UNITED STATES PATENT AND TRADEMARK OFFICE

APPLICATION NO.	FILING DATE	FIRST NAMED INVENTOR	ATTORNEY DOCKET NO.	CONFIRMATION NO.
10/020,447	12/18/2001	Thomas D. Fletcher	2207/11269	1709

Office Action Summary

FIGURE 3A

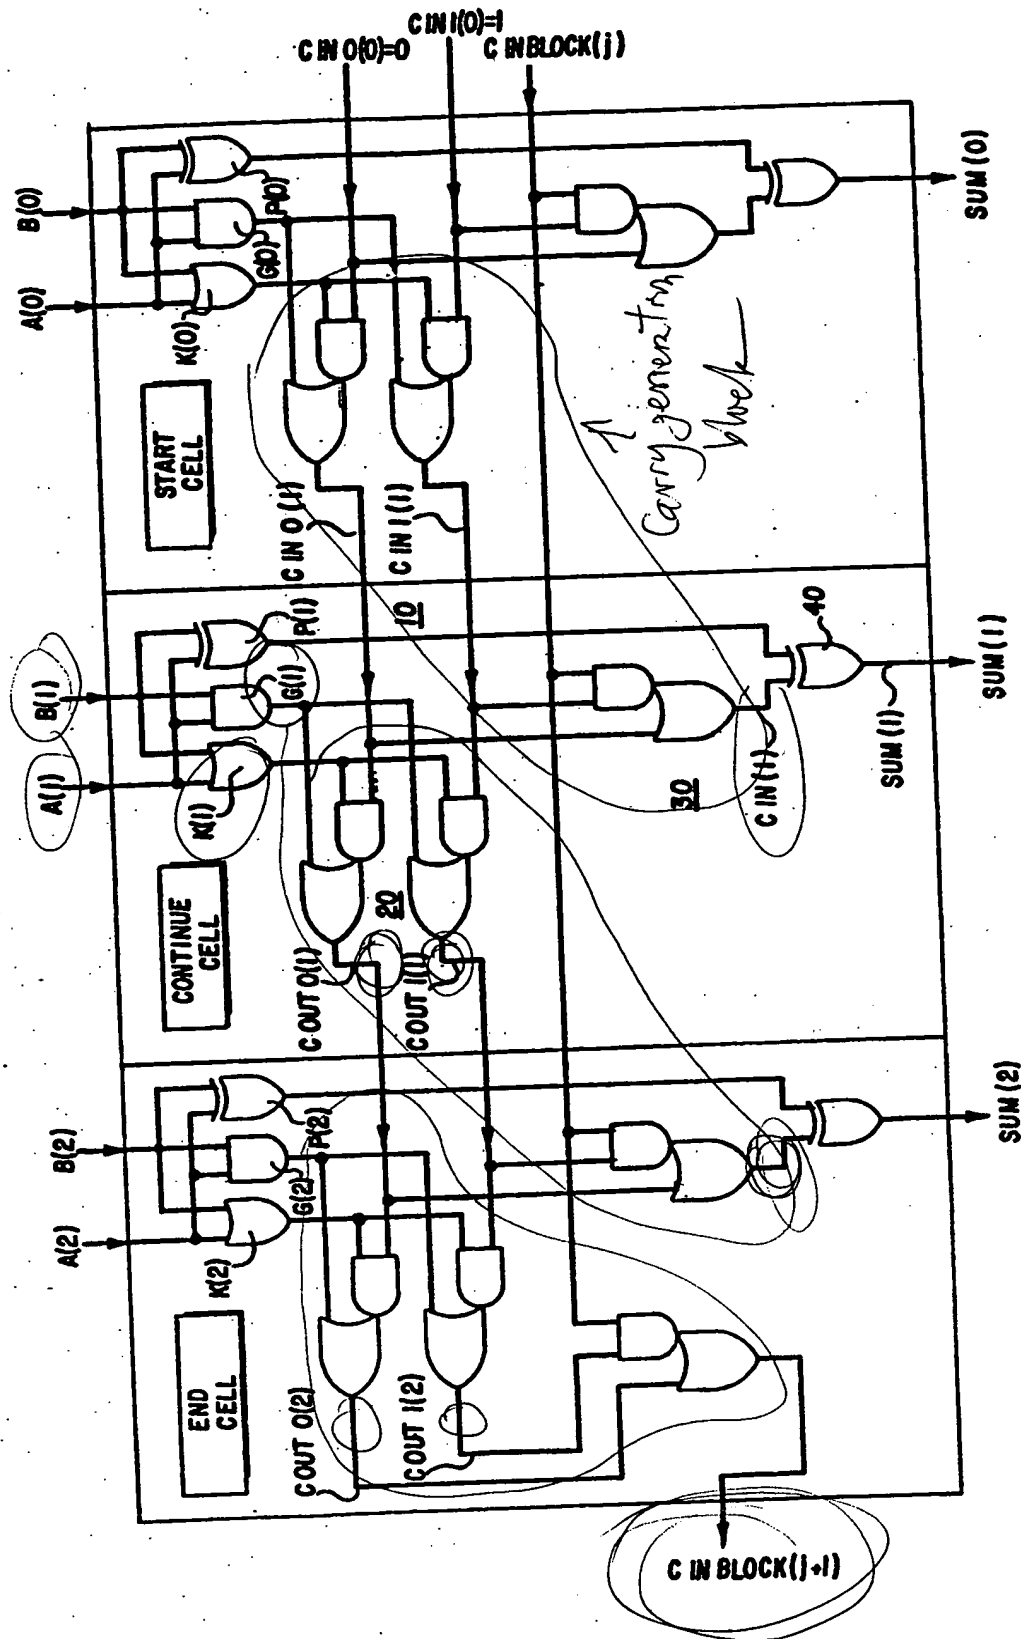
(1). First, Ware teaches all elements of the claim, see last Office Action, paragraph 5. It is noted that the last Office Action stated that "Ware does specifically detail the claimed 'one of the carry generation blocks determine exactly three of the carry-output values'". Also, it is noted that Fig. 3B shows a plurality of blocks having different bit length. Therefore, Fig. 3B discloses the claimed "one of the carry generation blocks determine exactly three of the carry-output values". See attached copy of Fig. 3A for the claimed "one of the carry generation blocks determine exactly three of the carry-output values";

(3). Third, Ware does show the claimed "one critical path through the plurality of carry generation blocks", e.g., see Fig. 3B (critical path C IN ADDER to C OUT BLOCK(3)).
